STATE OF NORTH CAROLINA
DEPARTMENT OF TRANSPORTATION

SUBJECT: Project 35993.1.1 (U-4700) Caldwell, Catawba, and Burke Counties
F. A. Project NHF-321(18)
Proposed US 321 Widening from US 70 in Hickory to Southwest Boulevard in Lenoir

**Post-Public Meeting
Meeting Summary**

Grace Chapel Road

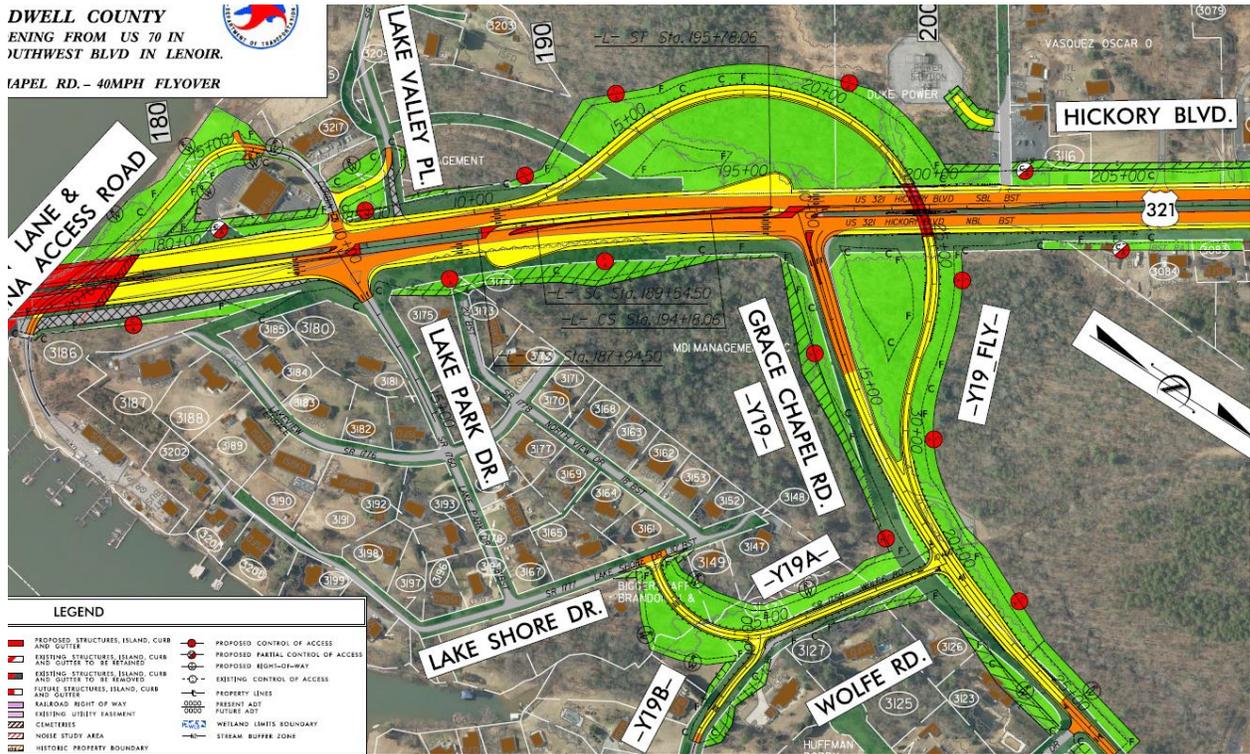
1. **Comment:** The new design benefits MDI and not residents.

2. **Comment:** A large proportion of this area’s arterial street traffic routinely turns left.

3. **Comment:** It will be difficult to access US 321 from Grace Chapel Road, Lakeview Park, and River Bend/New Farm Road.

6. **Comment:** The proposed design is ignoring a large population that lives near Grace Chapel Road and uses it to access 321.

7. **Comment:** There will be reduced access to Lakeview Park and Lake Park Drive, which is a concern for increased emergency response time and ease of daily traffic.

8. **Comment:** Keep the 2016 plans.

9. **Comment:** Leave the signal at Grace Chapel Road.

Response: Based on the updated forecast, none of these three intersections (Grace Chapel Road, MDI/Alex Lee Boulevard, Walmart/New Farm Road) require an interchange to address traffic operations or congestion concerns. At the July 2017 meeting, the interchange was proposed at a central location (Alex Lee Boulevard) to provide direct access for all users in this area. The recommended alternative proposes a flyover from Grace Chapel Road to US 321 South, and an interchange on US 321 at Alex Lee Boulevard/MDI.

Response: While a superstreet option provides a safe and efficient operation for motorists, the reverse superstreet and interchange alternatives initially presented in July 2016 would provide direct movements for the heaviest turn movement Grace Chapel Road, and the interchange presented in July 2017 would provide direct movements for the heaviest turn movements via Alex Lee Boulevard. Since Grace

Chapel Road and Alex Lee Boulevard intersect east of US 321, traffic from this area could use either route. The recommended alternative proposes a flyover at Grace Chapel Road and an interchange at Alex Lee Boulevard, providing a direct movement for left-turning vehicles from both roads onto US 321 Southbound.

Response: Although the route is slightly different, travel time would be on average shorter for the new alternatives compared with the existing roadway configuration. The reverse superstreet and interchange alternatives initially presented in July 2016 would address left turn demand more directly. The recommended alternative proposes a flyover at Grace Chapel Road. New Farm Road connects with Grace Chapel Road.

Response: Residents will be able to access US 321 from Grace Chapel Road via a flyover to US 321 South and a traditional superstreet intersection for the other movements; via a full tight diamond interchange at Alex Lee Boulevard, and via a traditional superstreet intersection at New Farm Road. Alex Lee Boulevard, New Farm Road, and Grace Chapel Road intersect east of US 321.

Response: The forecast and analysis accounted for this population and driving volumes.

Response: The design will be evaluated to determine if a more direct connection is feasible to this area.

Response: There were three options at Grace Chapel Road presented at the 2016 public hearing, based on the 2011 traffic forecast. This forecast assumed all traffic would be concentrated on Grace Chapel Road because New Farm Road was not in place at that time. Based on an updated traffic forecast (2017), a fourth option (a traditional superstreet) was added for consideration, and presented during the July 2017 public meeting. The recommended alternative proposes a flyover at Grace Chapel Road.

Response: With a traditional traffic signal, the intersection Grace Chapel Road at US 321 is projected to operate with long delays. Also, leaving the existing traffic signal at this location would interrupt the signal timing progression along US 321, affecting travel time and delay for all drivers on the corridor. With addition of a superstreet or a reverse superstreet, a signal would still be included to ensure drivers had sufficient gaps to get onto US 321. With the preferred alternative, a southbound flyover to US 321, a signal is proposed to remain at the at-grade intersection of Grace Chapel Road and US 321 to ensure drivers have sufficient gaps to turn right from Grace Chapel Road onto US 321, and to turn left from US 321 onto Grace Chapel Road.

Alex Lee Boulevard

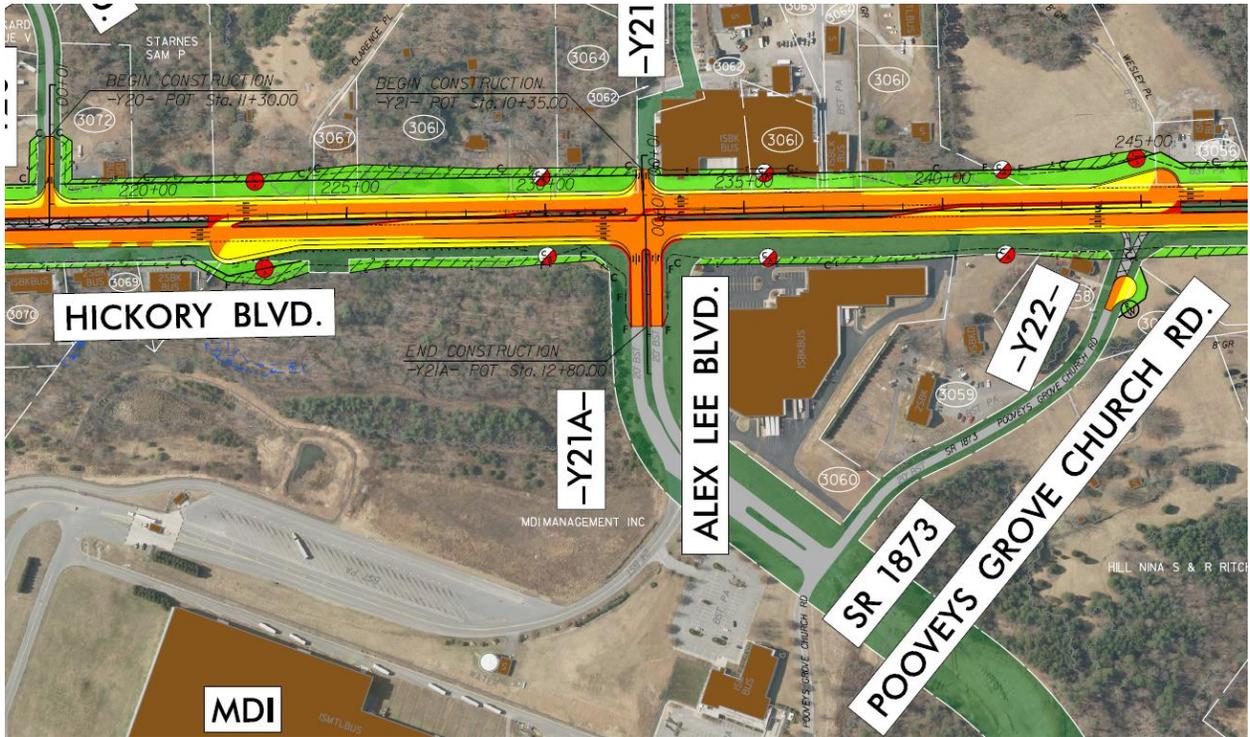
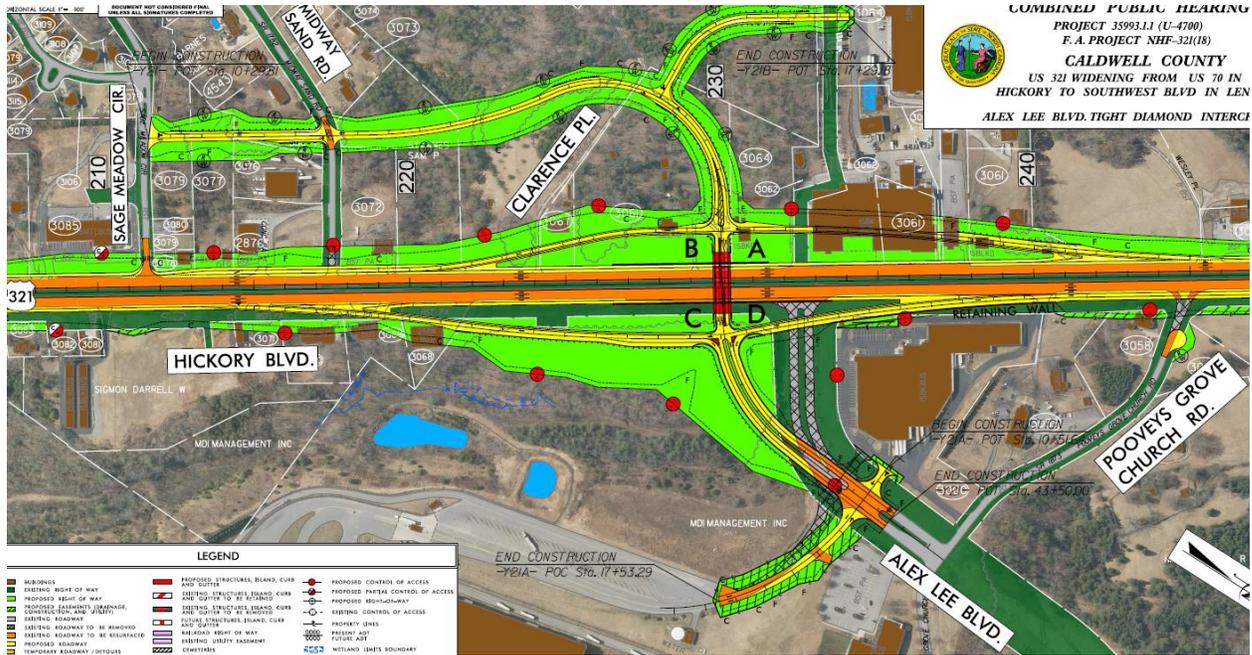
Stop the Caldwell County Hwy 321 Superstreet's Alex Lee Blvd Interchange

US Highway 321 in southern Caldwell County certainly has a traffic problem. Before relying on an experimental, unproven super street design to solve this issue, we encourage county officials, state representatives and the NCDOT to research alternatives to alleviate traffic in a safer & more efficient manner.

US Highway 321 in southern Caldwell County has a high-volume of vehicles entering & exiting to access many large Retail Centers, Businesses & Neighborhoods adjacent to Hwy 321. Residents, school buses and emergency personnel should be able to safely navigate this area.

Traffic backs up terribly at several large intersections now. With the new Superstreet design - those wanting to turn left to access Hwy 321 will be expected to enter & merge left across 3 lanes of traffic, into new U-turn bulbs. With the backups at those intersections now, sending them to these new U-Turn bulbs will create potential (& probable) dangerous backups onto US Highway 321 instead.

The current, July 2017 plans by the NCDOT provides only 1 interchange through this area at Alex Lee Blvd (not Grace Chapel Road or Wal-Mart/US 321-A). The traffic counts for Alex Lee Blvd (MDI) is no where near the traffic counts for Grace Chapel Road or WalMart/US321-A.

We are proposing the NCDOT replaces this Alex Lee Blvd Interchange with the 2016 proposed Flyover at Grace Chapel road. We are proposing that the NCDOT replaces this Alex Lee Blvd Interchange with a Flyover at WalMart/US321-A. This would greatly reduce backups at those U-Turn bulbs in those areas and increase the safety of the drivers. This would also reduce the amount of property, residents & businesses hurt by the proposed Alex Lee Blvd / MDI Interchange. And we feel this would be the most efficient & cost-effective manner to alleviate traffic concerns for US Highway 321 in southern Caldwell County.

Response: At the July 2016 public hearing, three options were proposed based on the 2011 traffic forecast: a flyover, an interchange, and a reverse superstreet.

The traffic forecast was updated in February 2017. Based on the updated forecast, none of these three intersections (Grace Chapel Road, MDI/Alex Lee Boulevard, Walmart/New Farm Road) require an interchange to address traffic operations or congestion concerns.

At the July 2017 public meeting, an interchange was proposed at a central location (Alex Lee Boulevard) to provide direct access for all users in this area. Although an interchange is not needed, the centralized interchange was proposed based on a desire from residents and businesses to more directly accommodate the left turn movement

from the area onto US 321. Grace Chapel Road, Alex Lee Boulevard, and New Farm Road intersect east of US 321, allowing traffic from this area to use any of the intersections.

The recommended alternative proposes a flyover from Grace Chapel Road to US 321 South, and an interchange on US 321 at Alex Lee Boulevard/MDI.

Falls Avenue

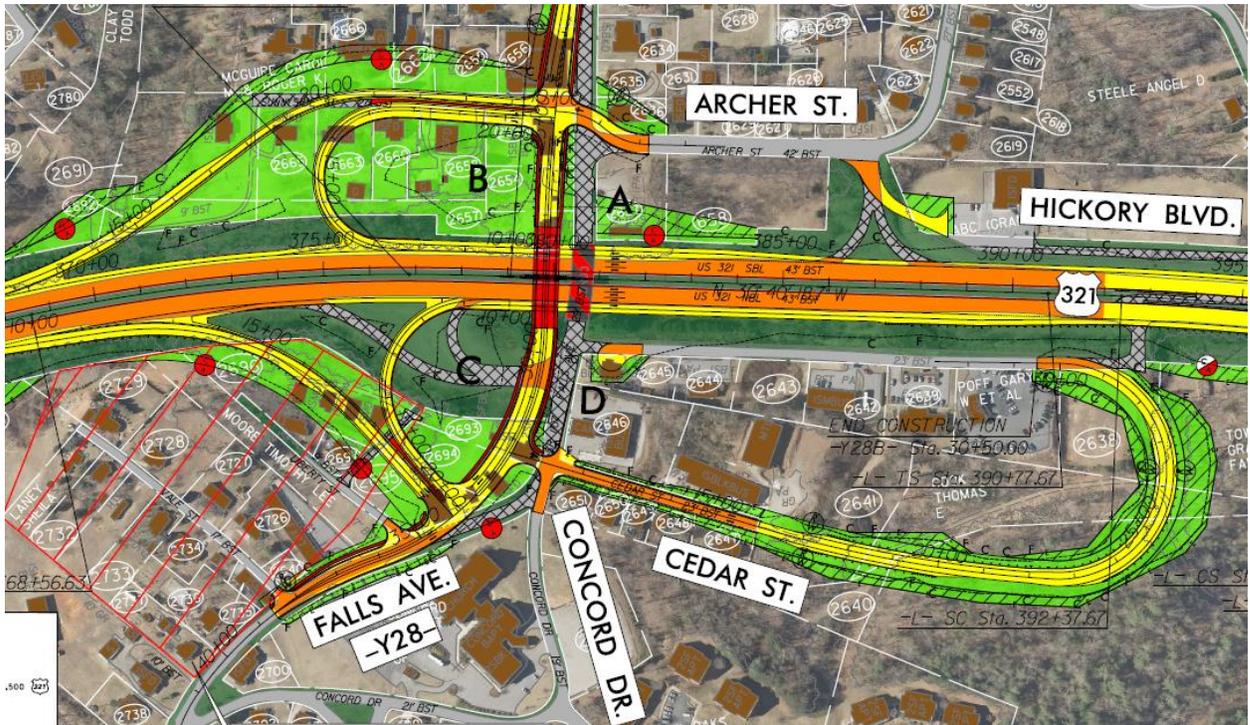
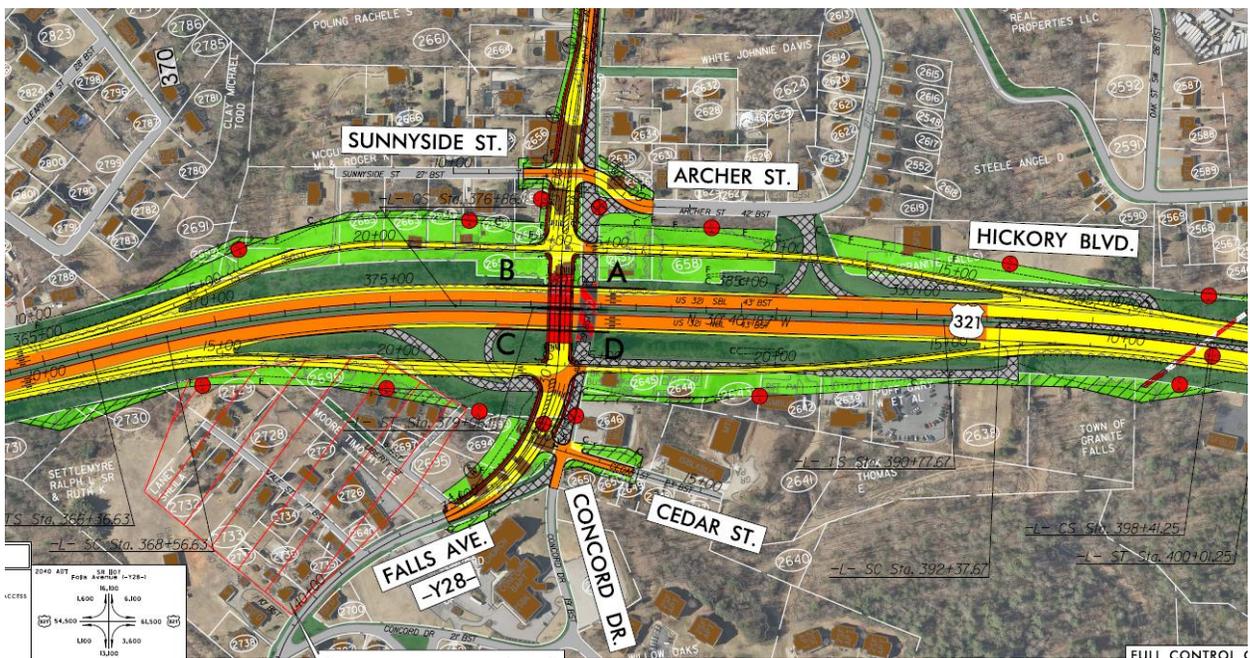
37. Comment: The Town of Granite Falls is concerned about accessing Falls Avenue for emergency travel times and has adopted a resolution to support alternative design #3 – Tight Diamond Interchange.

38. Comment: Easy access will be cut off to the Town of Granite Falls.

Response: NCDOT recommends the tight diamond interchange alternative at this interchange.

Response: The Town of Granite Falls will be accessed from US 321 via a diamond interchange, retaining similar movements as the current interchange.

Clement Boulevard

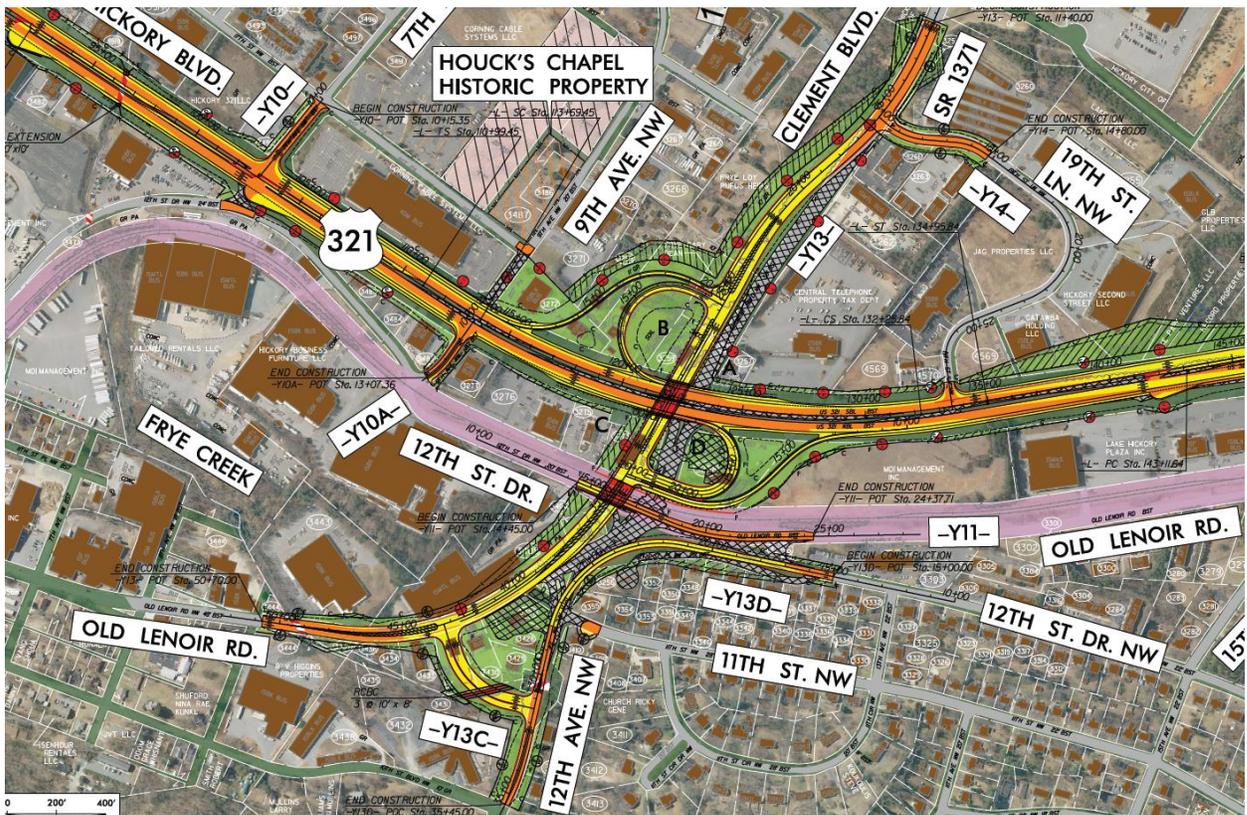
- 10. Comment:** Bond money is currently allocated to build a corridor connecting downtown to the lake for bike and pedestrian use. This will need to be accessed by Clement Boulevard.

- 11. Comment:** Traffic to/from Crawdads Stadium will be disrupted during construction and upon completion of construction.

- 12. Comment:** The superstreet will negatively affect surrounding businesses, baseball stadium, airport, etc. There is a group of investors looking at the large building next to the stadium and at creating an arts/innovation district south of Clement Boulevard on US 321. The superstreet will disrupt these projects.

- 13. Comment:** Traffic currently crossing US 321 will be inconvenienced and travel time increased with a superstreet compared with an interchange.

- 14. Comment:** There is too much volume present on the cross-streets at this location to be acceptable for a super street.

Response: This has been accommodated in the current design.

Response: The project team will continue to coordinate with the Crawdads, and will look at accommodating the heaviest movements through traffic signal timing. Traffic counts are being collected at the stadium for this study. Access during construction will be evaluated during the final design period.

Response: Overall travel time is better with superstreets than with traditional intersections. There is no evidence to indicate that conversion from a traditional signalized median-divided facility to a superstreet corridor negatively impacts businesses.

Response: An interchange, which had previously been proposed at this location, is no longer needed based on the updated traffic forecast.

Response: Based on the capacity analysis, the proposed superstreet design will provide acceptable operations.
